**ADDENDUM No. 3 TO THE
FINAL ENVIRONMENTAL IMPACT REPORT
Carpinteria Valley Water District's
Water Storage Tank Project
And Rancho Monte Alegre Annexation**

September 12, 2007

BRIDGE SITE & ROAD APPROACH PLAN
 CARPINTERIA VALLEY WATER DISTRICT ACCESS ROAD
 SANTA MONICA CREEK BRIDGE PHASE 5
 RANCHO MONTE ALEGRE PROJECT
 COUNTY OF SANTA BARBARA, CALIFORNIA
 SHT. 5 OF 23
BP-5

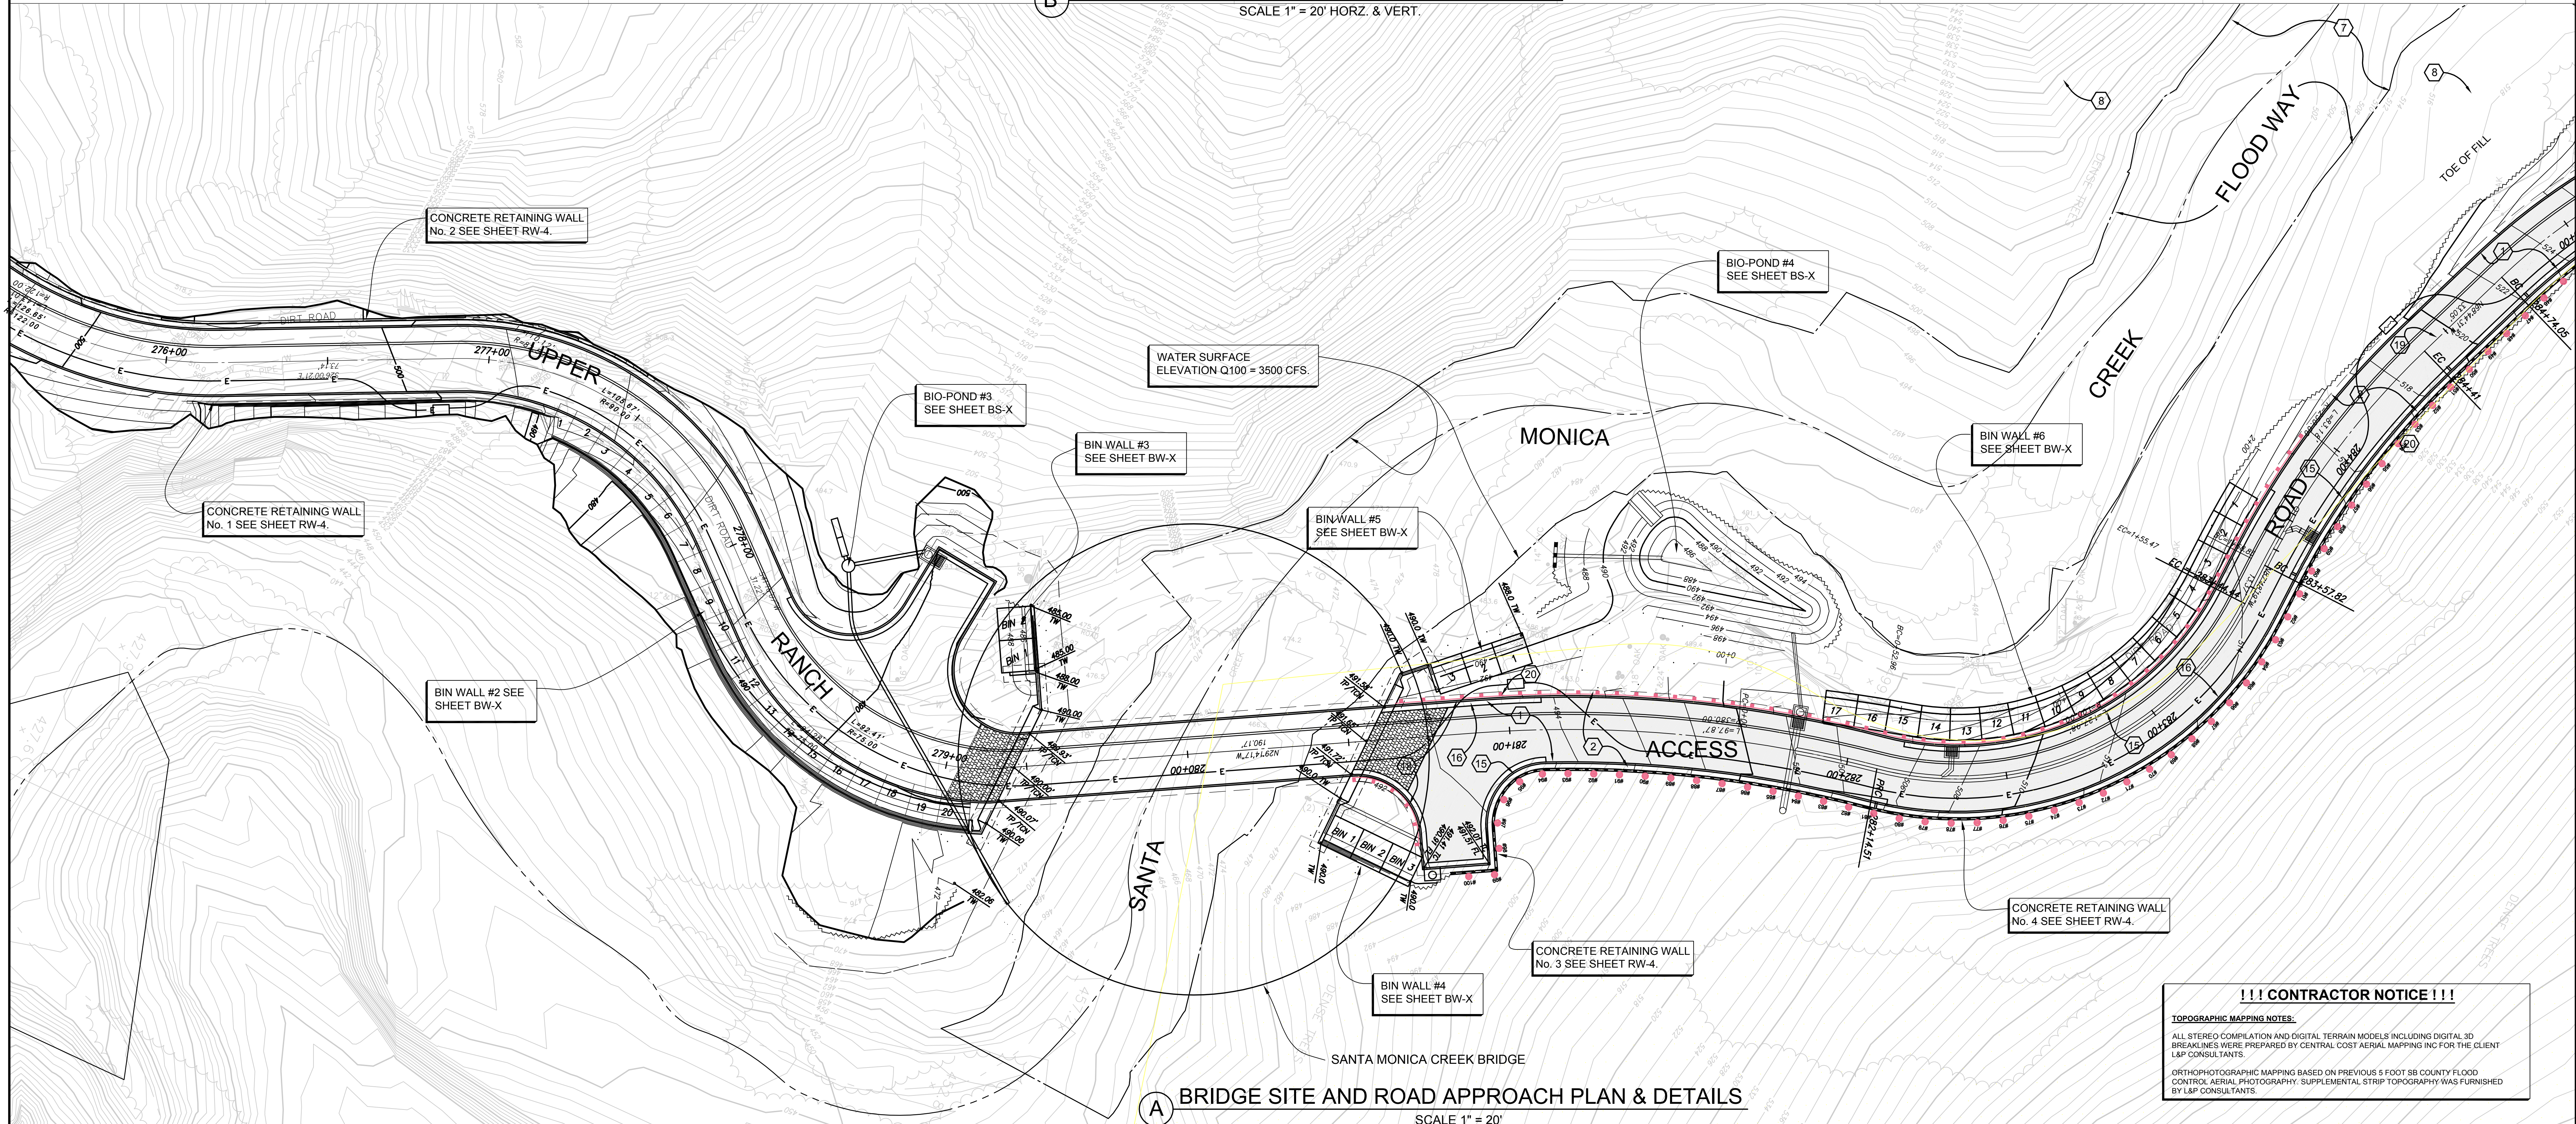
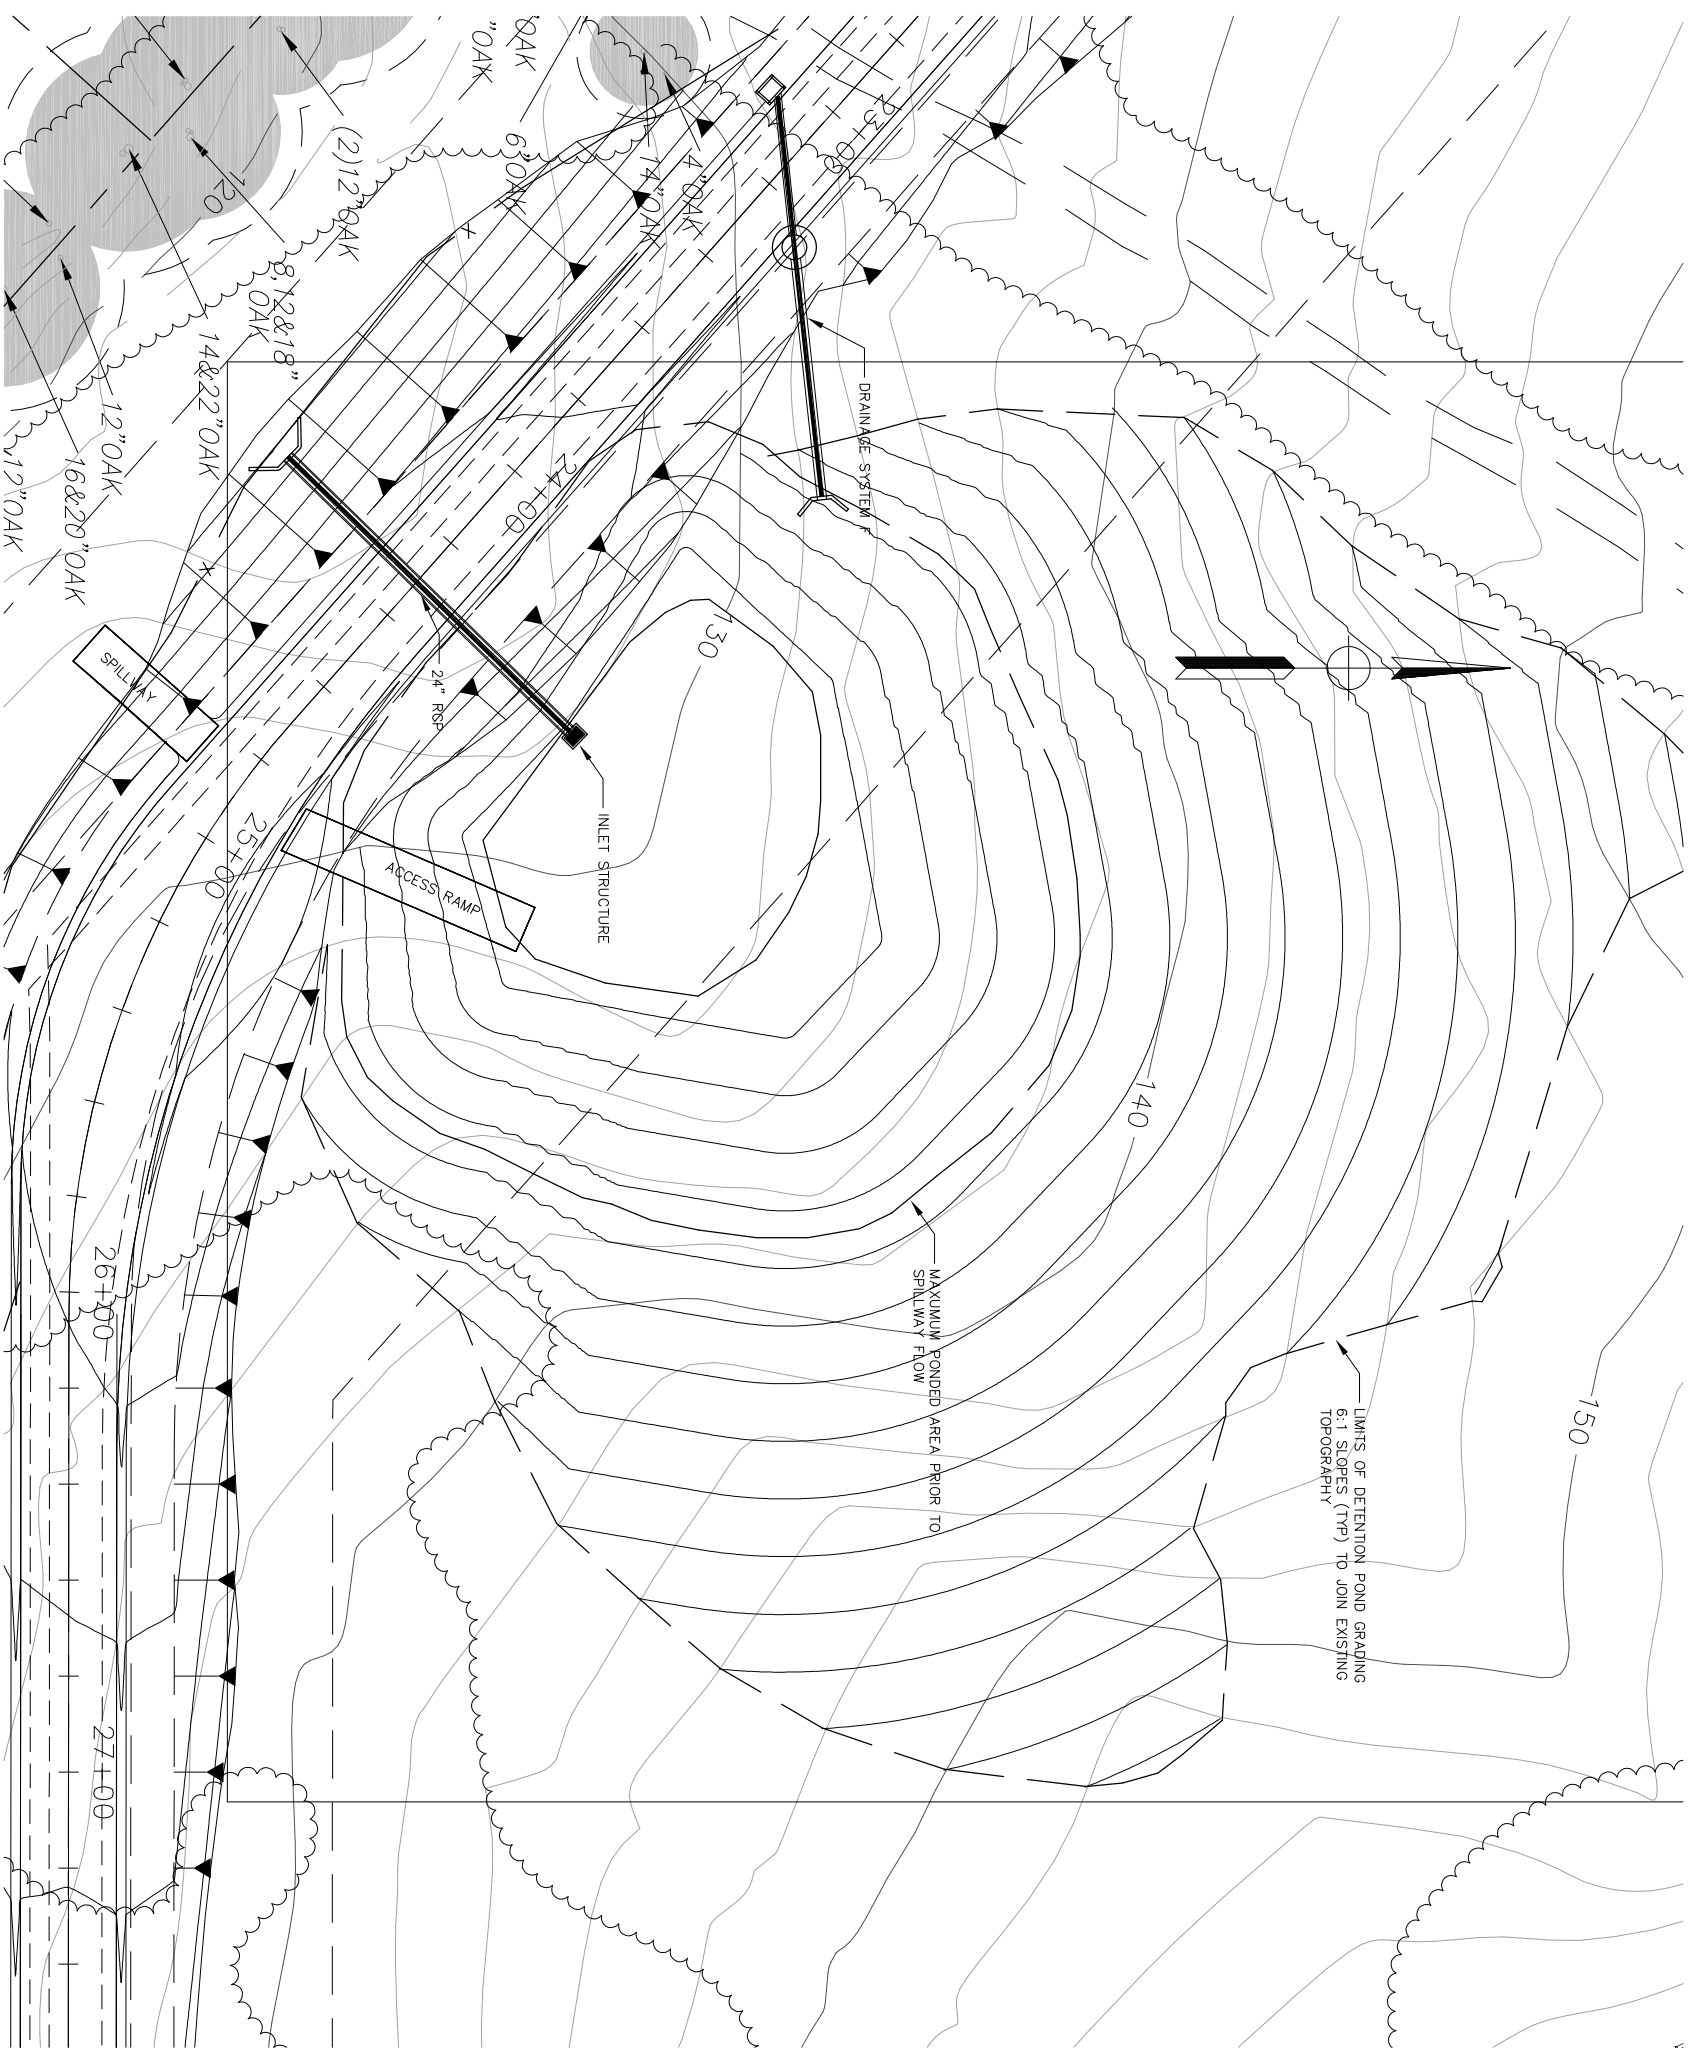
Presently, the project involves the installation of a pre-fabricated steel truss bridge with concrete deck over Santa Monica Creek with a 110 foot-wide span. The proposed bridge would be located approximately 60 feet southeast (downstream) of the existing road crossing. The bridge would have a travel lane width of 20 feet $\frac{1}{4}$ inch with an outside truss to truss width of 27 feet and 2 $\frac{1}{2}$ inches with guard rails (see Contech bridge sections and Flowers Bridge Site and Road Approach Plan in Attachments Section of this Addendum). The bridge would be supported on abutments located away from the stream banks and outside CDFG and Corps of Engineers jurisdiction. The Streambed Alteration Agreement with the California Department of Fish and Game and letter of concurrence of “no take of federally listed species” from the United States Fish and Wildlife Service are based upon a bridge plan that included installation of prefabricated steel truss bridge with concrete 110 feet long deck over the creek. The bridge was proposed to be 26 feet wide (outside truss to outside truss) with a 20 foot-wide traffic lane with guard rails. The most current plans will need to be submitted to these agencies.

PROJECT NUMBER	12207A
DRAWING NUMBER	15-C-06R
SHEET NUMBER	13 OF 33

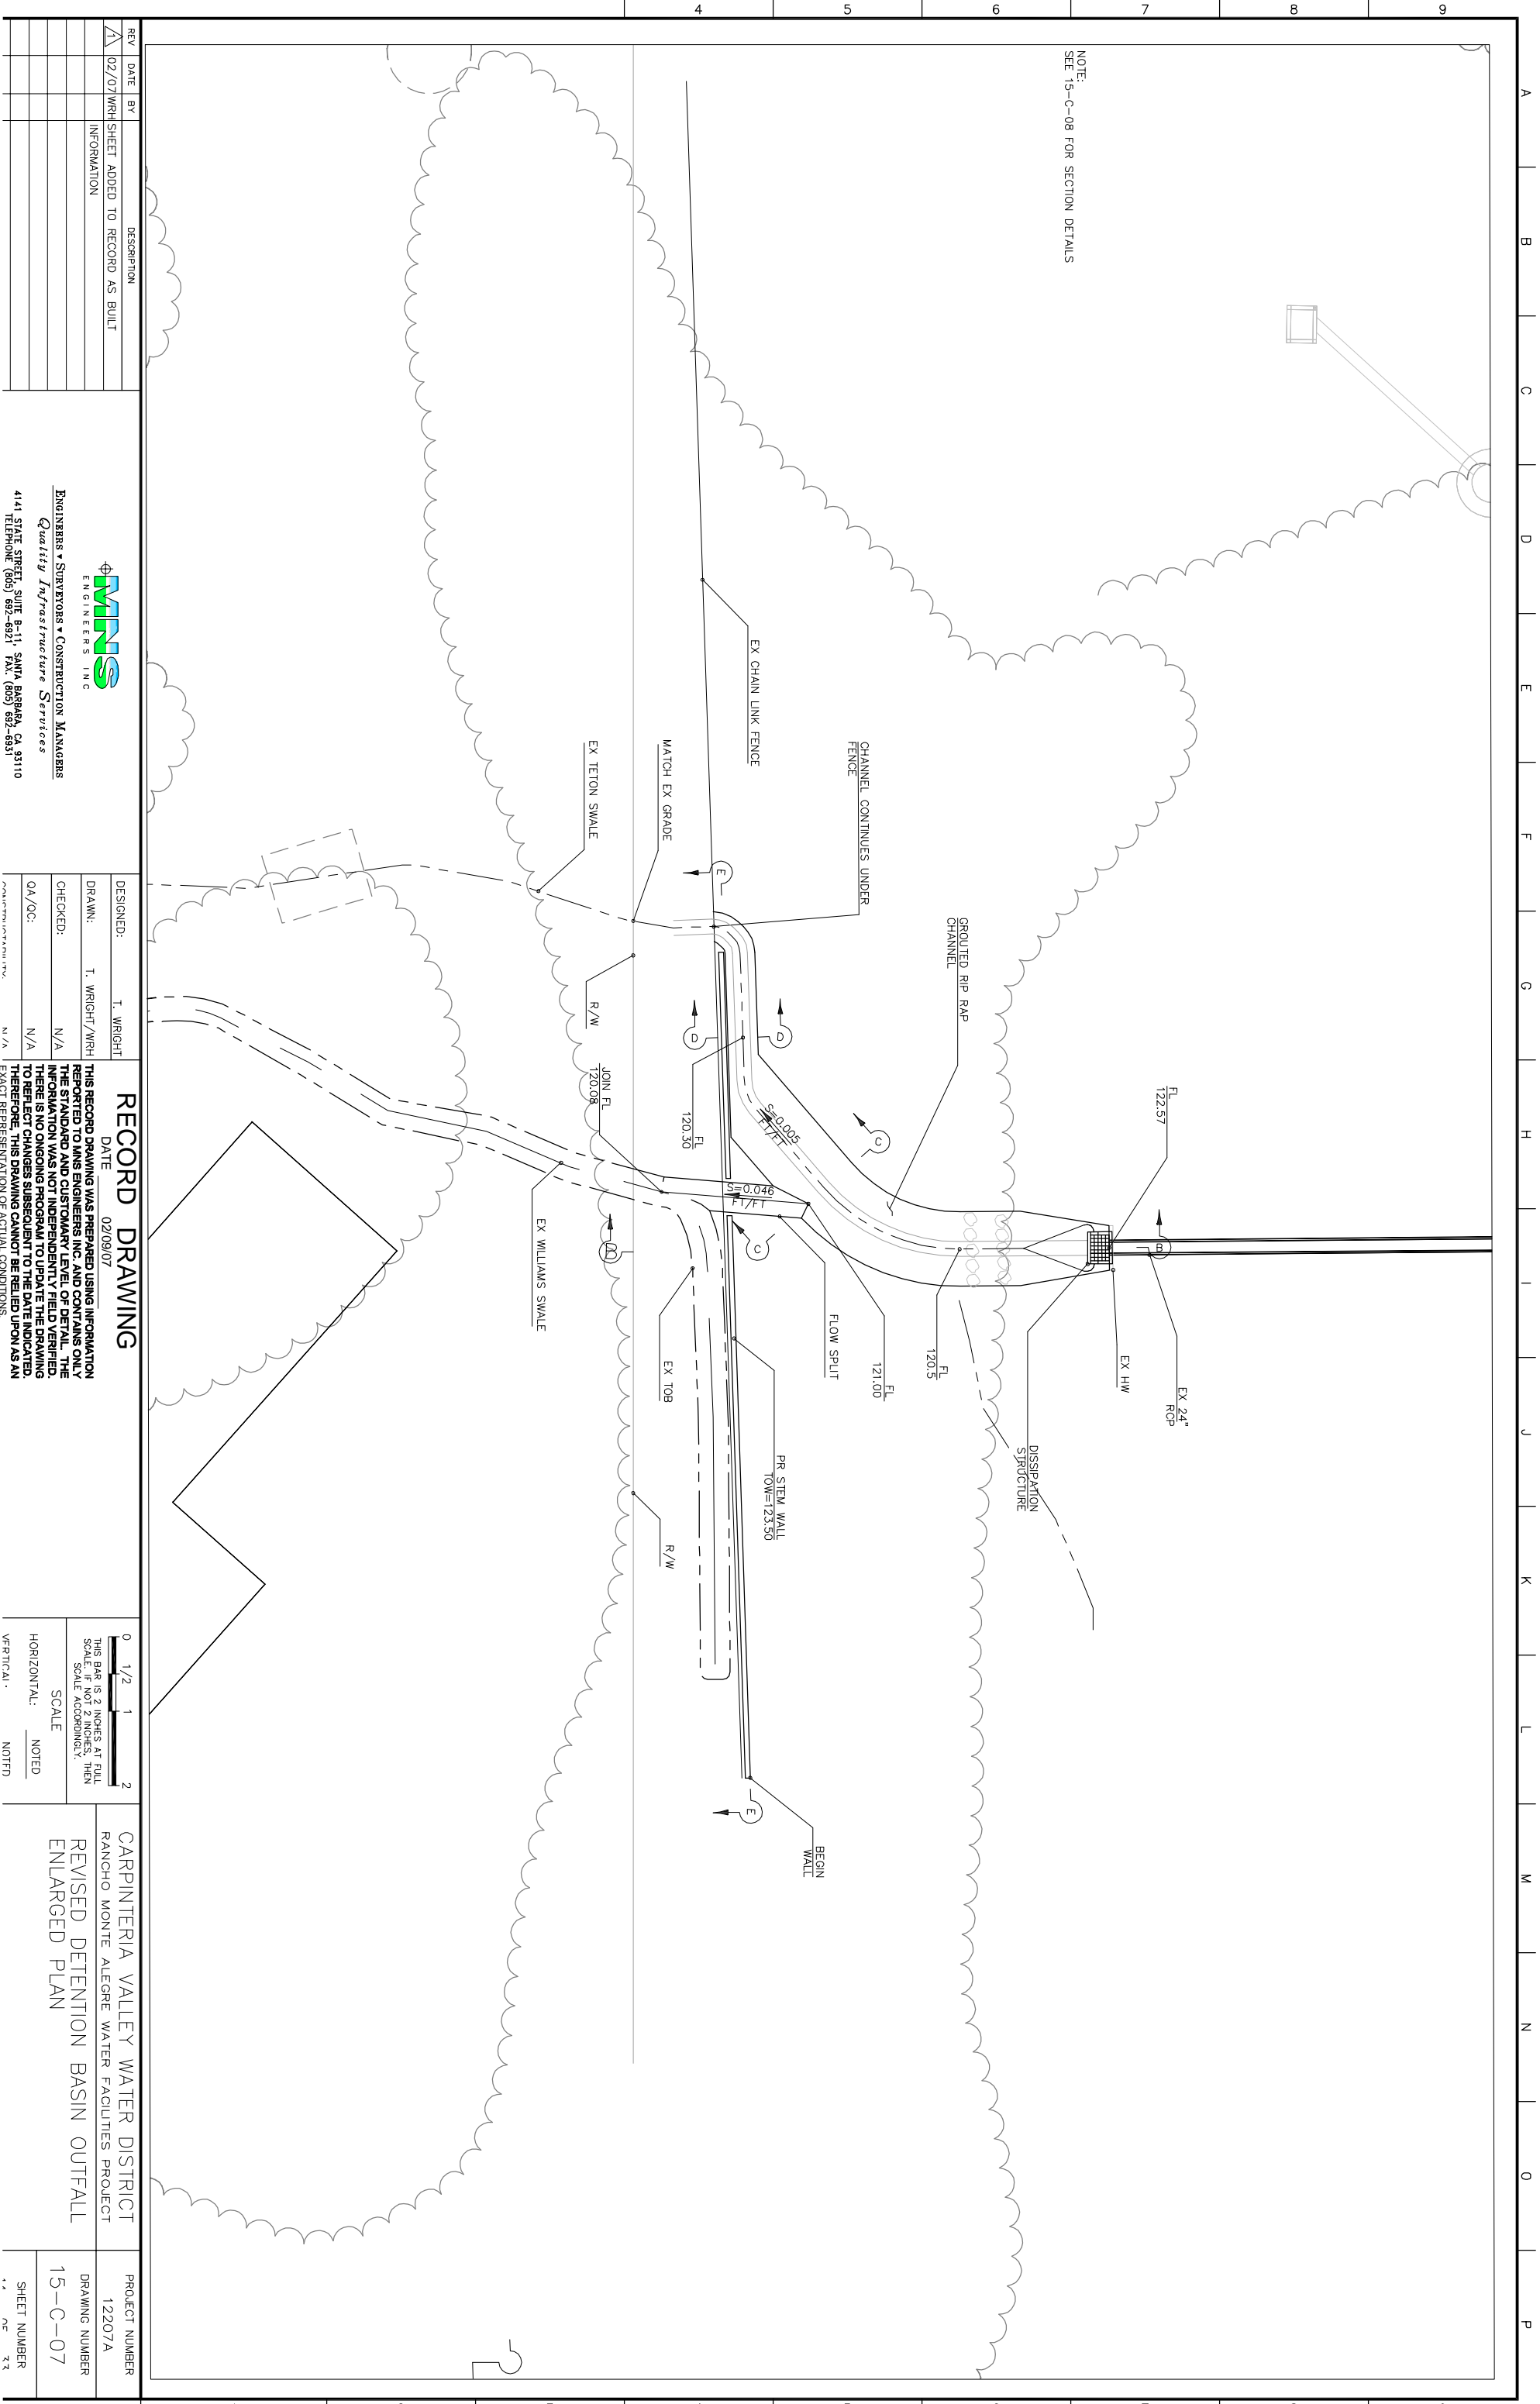
The construction of a detention basin on the lower ranch property was not specifically identified in the FEIR project description or the two Addendums to the FEIR. However, mitigation incorporated into the project called for the development and implementation of an erosion control plan for the project (see DEIR Project Description page 3-40, measure 2). As part of the detailed project engineering a detention basin was added to the project for the attenuation of peak runoff at the site. This detention basin was shown on project plans as permitted by the County of Santa Barbara (see drawing numbers 15-C-05 and 15-C-06) and was later modified as shown on drawings 15-C-05R and 15-C-06R (see Attachments to this Addendum).

The basin was constructed with rock lined steepened sides to minimize the footprint while still maintaining necessary detention storage as the owner of the property did not want to lose any more of the existing avocado grove than necessary. The change to the pond was a field change approved by RMA and the District.
